Work Order ID 129090

Item Name: Replacement Skidtube, Low & High Gear with Standard Wearplates Fits LH or RH

DRAWING NO. D2650	TITLE 206/407 SKIDTUBE ASSEMBLIES	REV. F	DART AEROSPACE LTD ENGINEERING ORDER		D.E.O. NO. D2650-F-1	SHEET NO. SHEET 1 OF 1	SCALE NTS
DRAWN <i>JP</i>	CHECKED <i>A.P.</i>	MFG. APPR. <i>DA</i>	APPROVED <i>HA</i>		DE APPR. <i>HA</i>		
DATE 12.10.12	DATE 12.10.22	DATE 12.10.22	DATE 12.10.22		DATE 12.10.22

ADD DETAIL G BELOW, WHICH IS THE SAME SECTION VIEW AS DETAIL D OF DWG.

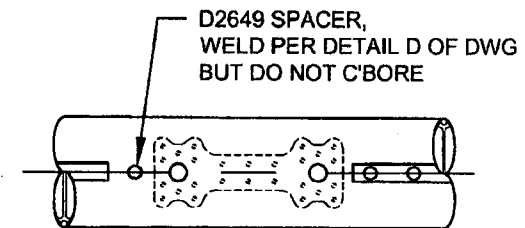
PURPOSE:

CHANGE C'BORED WELDED CROSSBOLT SPACERS TO SWAGED SPACERS

C'BORED HOLES ARE **NOW SWAGED** PER DETAIL G BELOW. FOR THE Ø0.375 HOLE THAT IS NOT C'BORED, WELD PER DETAIL D OF DWG (SEE AMENDED DETAIL B FOR REFERENCE).
